We appreciate the opportunity of reviewing a draft copy of document SD-BWI-TS-007, "Applicability of the Van der Kamp Method in Slug Test Analysis." The report has been examined by the hydrogeology staff of the Division of Waste Management; by Golder Associates, Inc.; and by Roy Williams and Associates, Inc.. This letter transmits to you the comments of the NRC staff. Also, attached for your information are copies of the comments from Golder Associates and Roy Williams and Associates.

TO: Mark Logsdon
FROM: Jerry Rowe
SUBJECT: Contract No. NRC-02-82-045
BWIP Hydrogeology
Review of Van der Kamp Method
Letter No. 57

Review of
APPLICABILITY OF THE VAN DER KAMP METHOD
IN SLUG TEST ANALYSIS

Figure 1

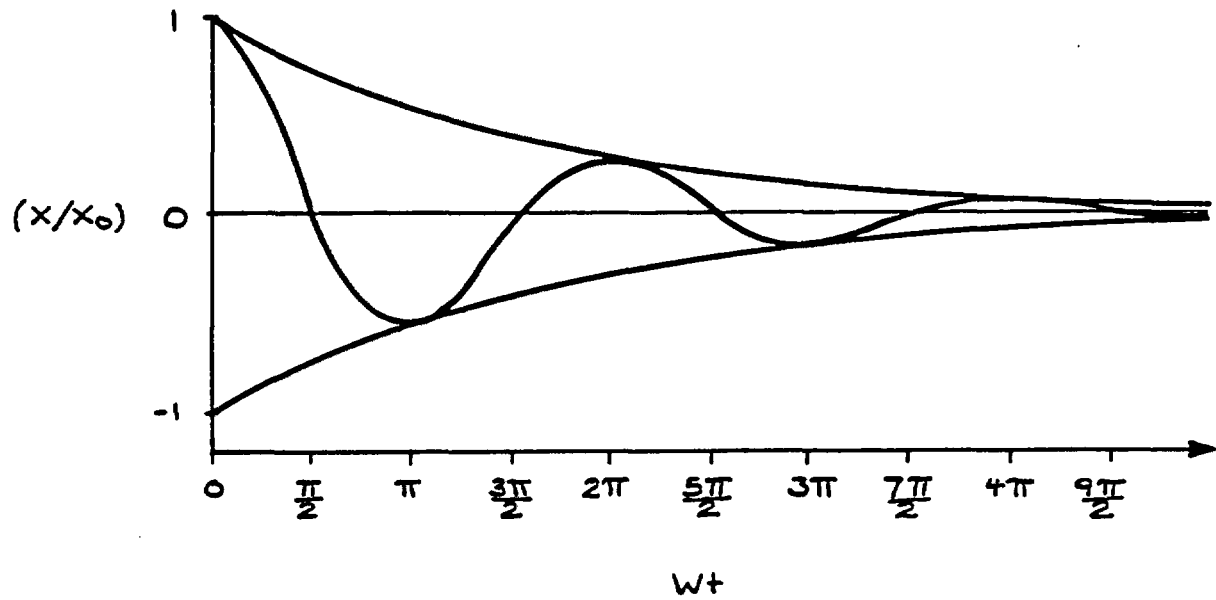
Analyses were conducted to estimate the effect of frictional losses in the wellbore. The typical underdamped response shown in Figure 1 is described by the equation

Differentiating (1) with respect to time and noting that the maximum slope of the oscillating response in Figure 1 occurs at $\omega t = (2n-1)\pi/2$, where $n = 1, 2, 3, \dots$, an expression for maximum velocity is obtained,

The envelope defining the maximum amplitude of the oscillation is given by

Figure 2

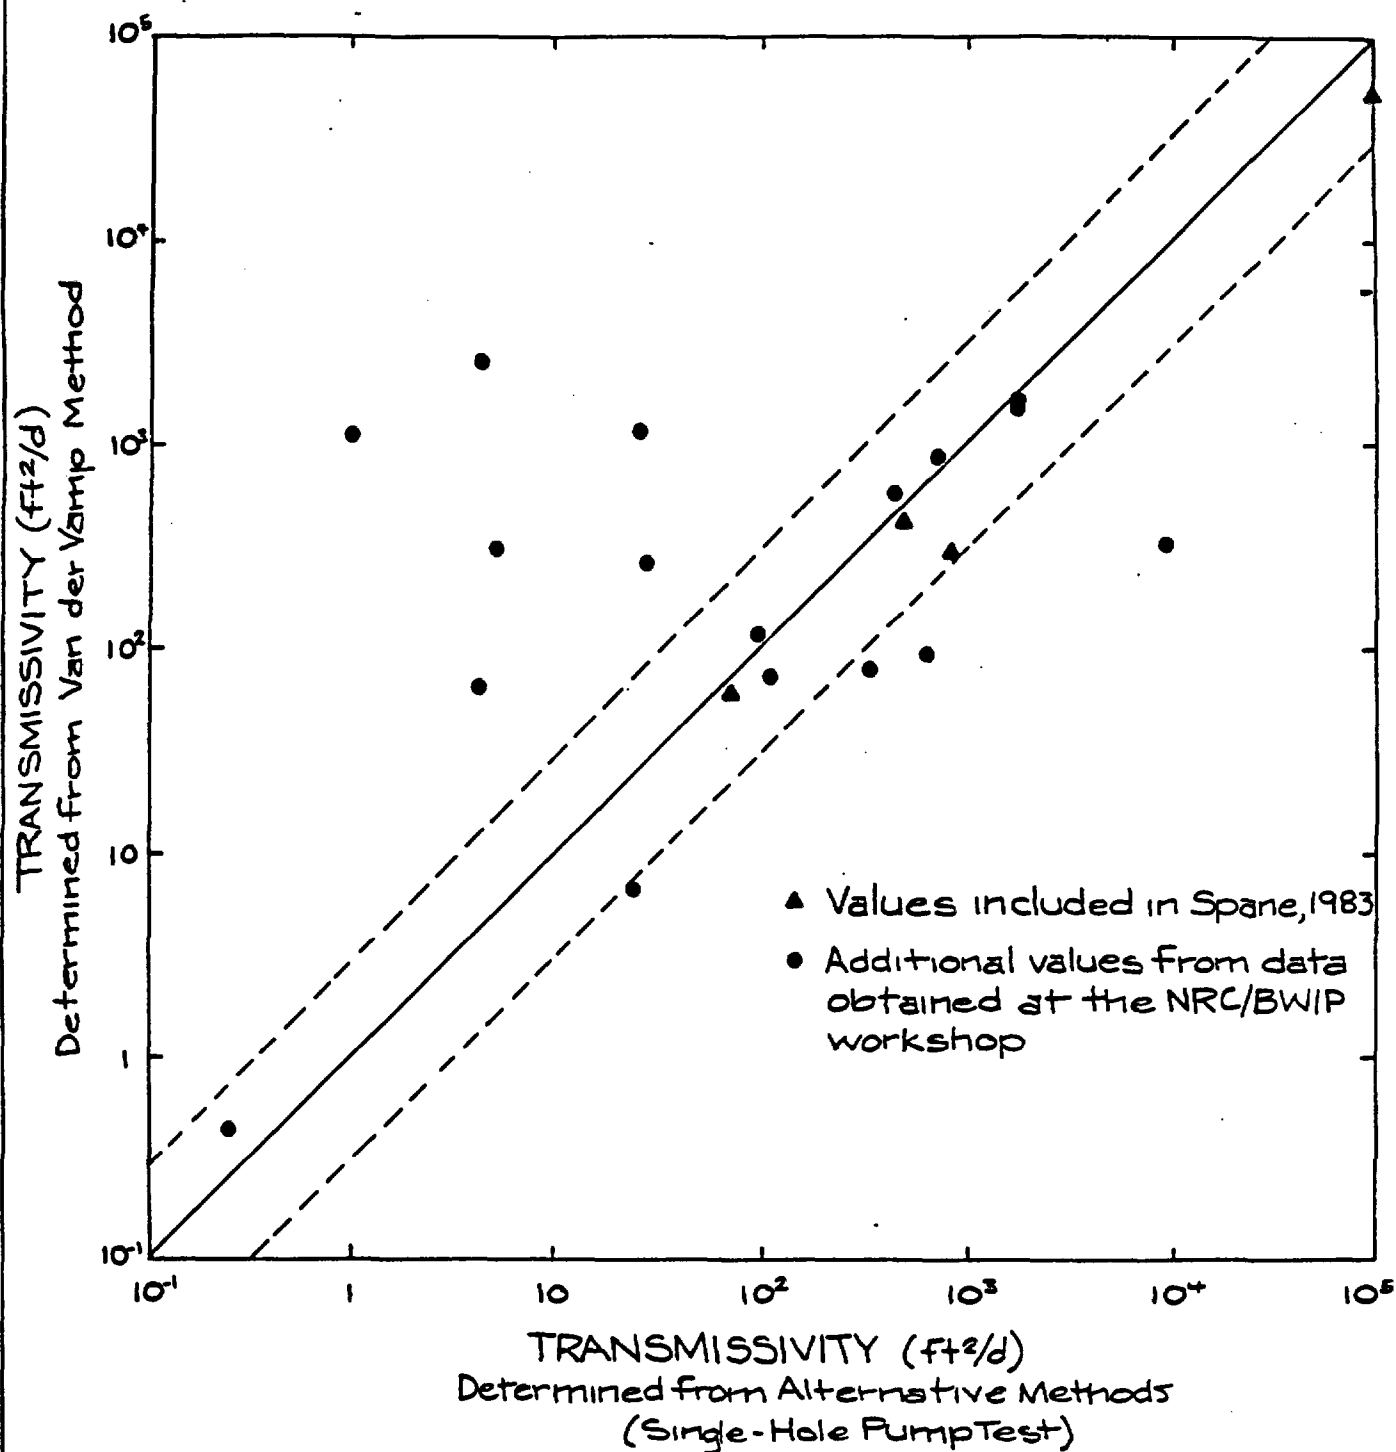
The transmissivity values determined by the Van der Kamp method are plotted versus values determined by alternative methods (e.g., single-hole pump tests) in Figure 2. The solid line represents a one-to-one correspondence between values determined by both methods while the dashed lines represents a factor of three difference. Of the twenty-one tests plotted on Figure 2, eleven fall within the factor of three range. However, a number of points fall well outside the range. We do not have the information to determine whether these results can be explained by careful examination or re-analysis of the test data.

The obvious conclusion is that in many cases, the values of transmissivity determined by the Van der Kamp method are significantly different from those determined by other methods and that one must question the validity of the results. Furthermore, in zones where the Van der Kamp method was used exclusively (twelve such zones are indicated in Table 3) it is questionable whether the values of transmissivity are meaningful estimates.

Where alternative testing methods suggest relatively low transmissivities in Figure 2 ($T < 30 \text{ ft}^2/\text{day}$), it is interesting to note that six of eight Van der Kamp values lie well above the 1:1 correlation line. This apparent over-estimation of transmissivity may indicate instances where the underdamped response was dominated by wellbore characteristics. In these cases, sole use of the Van der Kamp method could have led to erroneous conclusions regarding site conditions.

Where alternative testing methods suggest relatively high transmissivity ($T > 30 \text{ ft}^2/\text{day}$), ten of thirteen Van der Kamp values are below the 1:1 correlation line. In these cases, frictional head losses in the riser pipe may have caused the Van der Kamp method to underestimate aquifer transmissivity.

FIGURE 1. Expected Well Response Behavior for Slug Tests Conducted Under Common Hanford Test Conditions. (Figure 8)

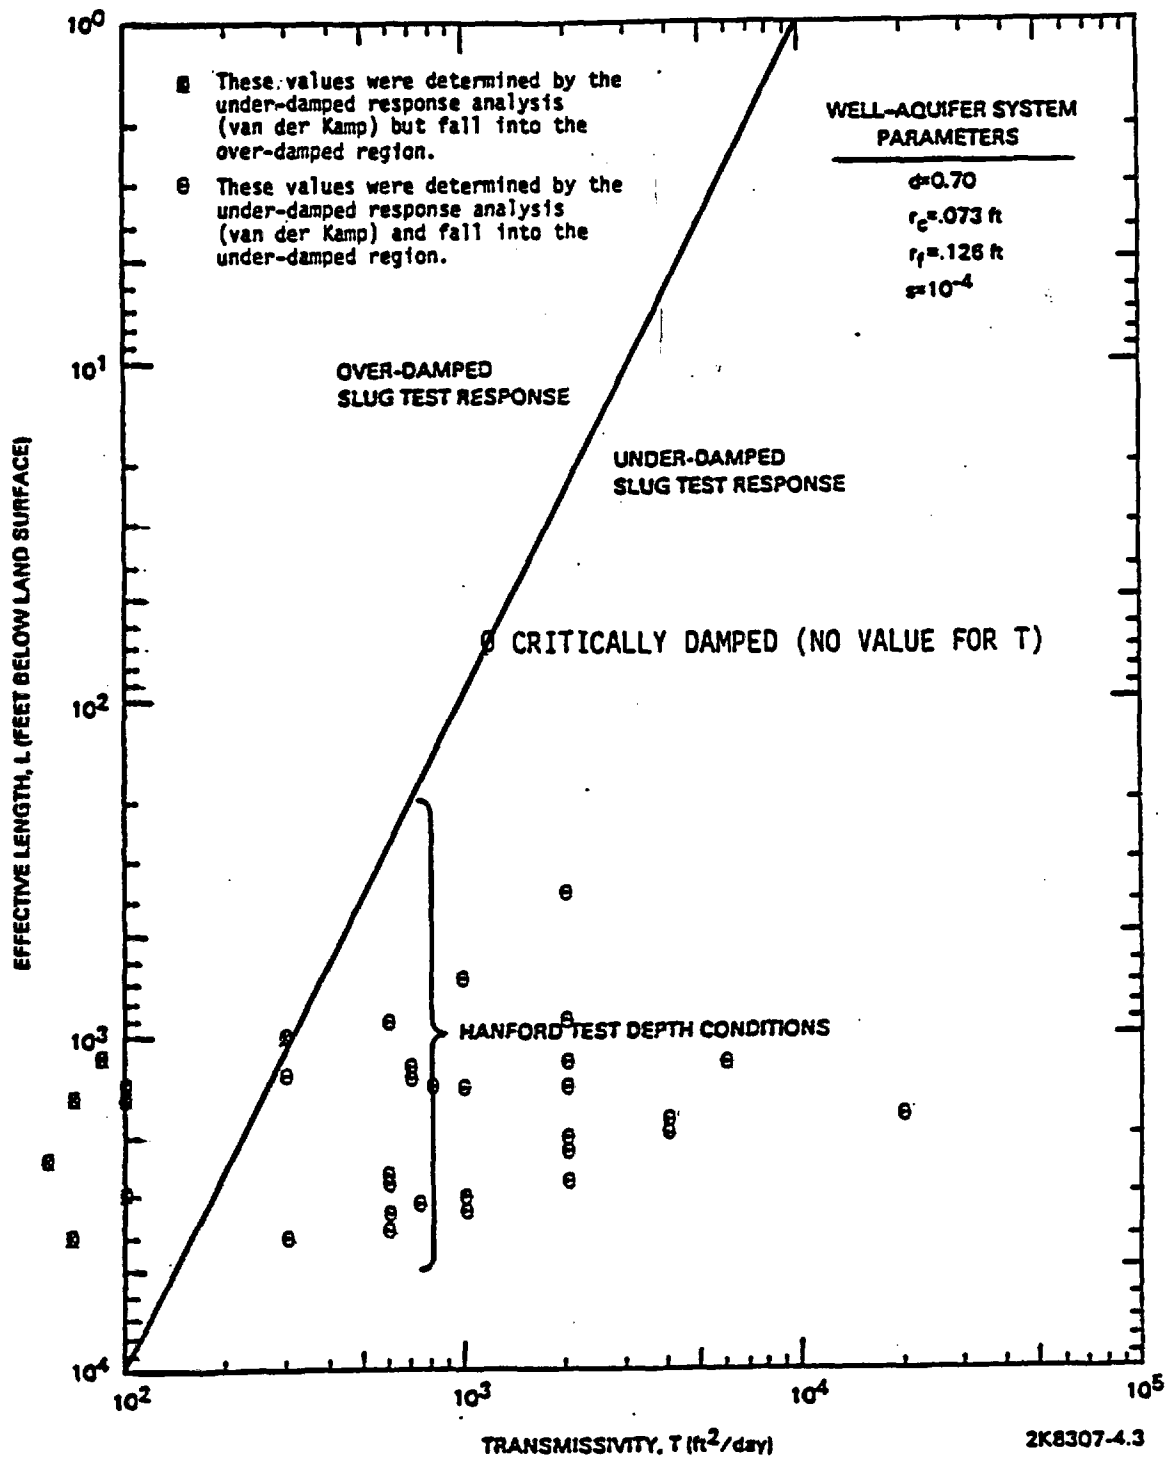
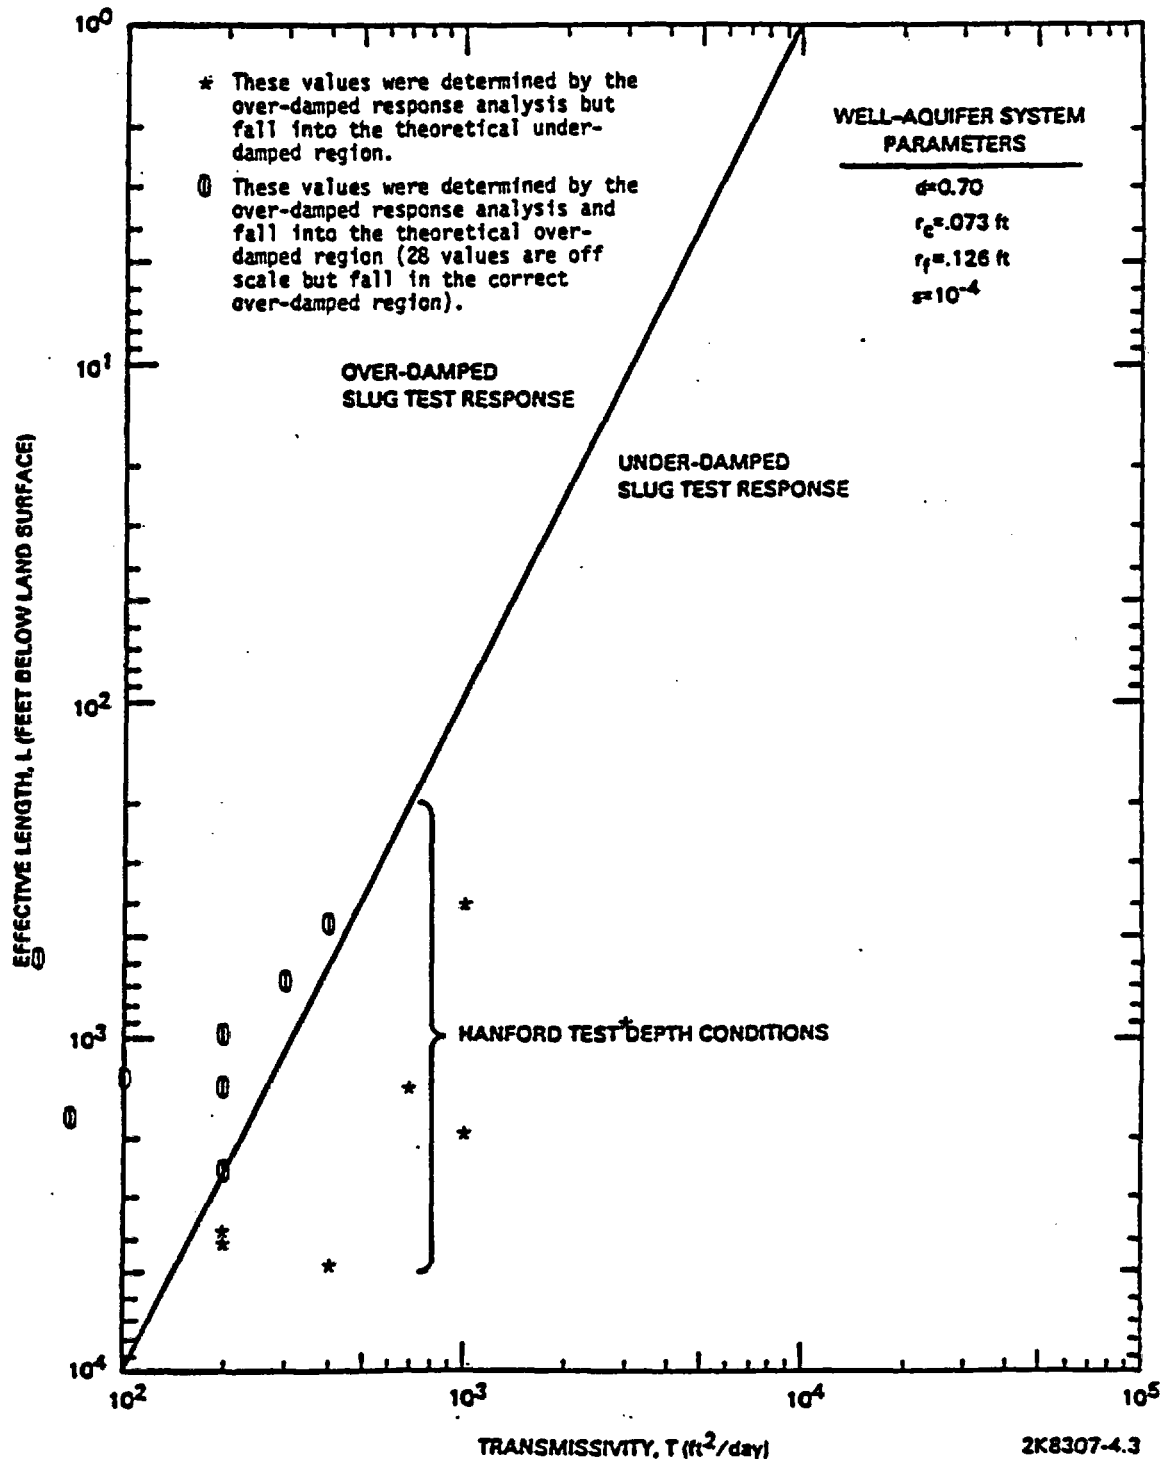
Figure 8 of the document under review (p. 21) shows that the van der Kamp method should yield no values of transmissivity below a threshold limit of 10^2 ft²/day on the Hanford site for the conditions specified by Dr. Spane. We plotted the actual transmissivities determined from the van der Kamp method versus the approximate length of the water filled tubing on Figure 1 (modified from Rockwell's Figure 8). We obtained these data during the July 1982 workshop held in Richland, Washington. We obtained 7 transmissivity values out of a total of 35 that were calculated based upon an under-damped water level response (van der Kamp method) that plot in the over-damped (wrong) region of Figure 1. We also plotted on Figure 2 17 of the 45 transmissivities obtained at the workshop that were determined using the over-damped water level response method. Seven of these transmissivity values calculated based on an over-damped response fall in the under-damped (wrong) region of this figure. Twenty-eight of the transmissivity values obtained at the workshop could not be plotted on Figure 2 since these transmissivity values were less than 10^1 ft²/day. These values, if plotted, would fall in the correct portion of the graph. We believe that this figure exemplifies the uncertainty of this technique.
